SERVICE BULLETIN

M-1208A

Safety Recall Code 0131

2006-2007 XL EXHAUST SHIELD RECALL

Figure 1. Inner Exhaust Shield Installation on Rear Exhaust Pipe

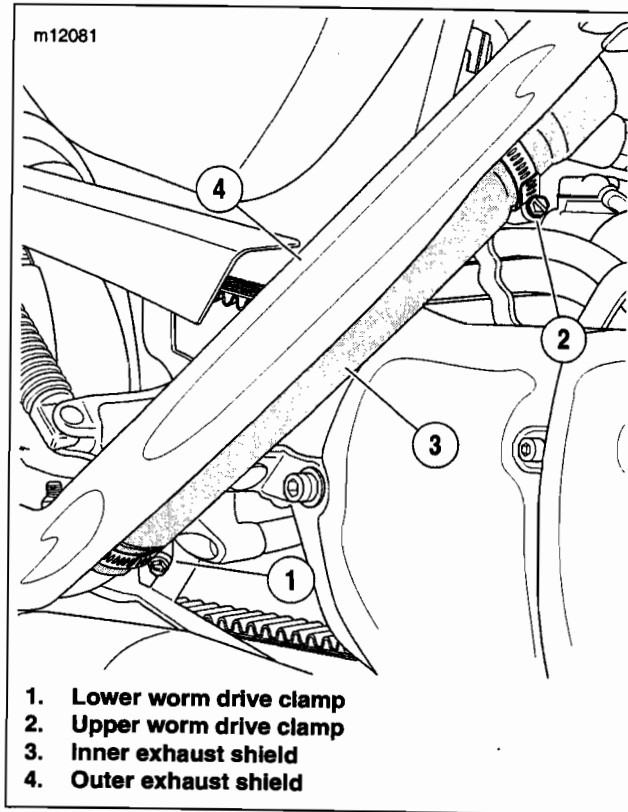
See Figure 1. If the vehicle is equipped with an original rear exhaust pipe (header) which does not have the inner exhaust shield installed, proceed to the installation instructions.

1. See Figure 1. Loosen the lower worm drive clamp (1) on the rear exhaust pipe.
2. Loosen the upper worm drive clamp (2).
 - a. See Figure 2. On 2006 model vehicles, loosen the upper worm drive clamp. Rotate the clamp (1) to accommodate the installation of the inner exhaust shield as shown.
 - b. On 2007 model vehicles, completely unfasten the upper worm drive clamp until the clamp opens.
3. See Figure 1. Slide the bottom portion of the **new** inner exhaust shield (3) against the exhaust pipe and into the lower clamp. The clamp should rest on the indented portion of the inner exhaust shield.

4. Tighten lower clamp securely.
5. Place the upper portion of the inner exhaust shield against the exhaust pipe.
6. Install the upper worm drive clamp(s).
 - c. See Figure 2. On 2006 model vehicles, install a **new** worm drive clamp (Part No. 9955) on the indented portion of the inner exhaust shield. Tighten both upper clamps securely.
 - d. See Figure 1. On 2007 model vehicles, install the upper clamp over the indented portion of the inner exhaust shield. Tighten clamp securely.
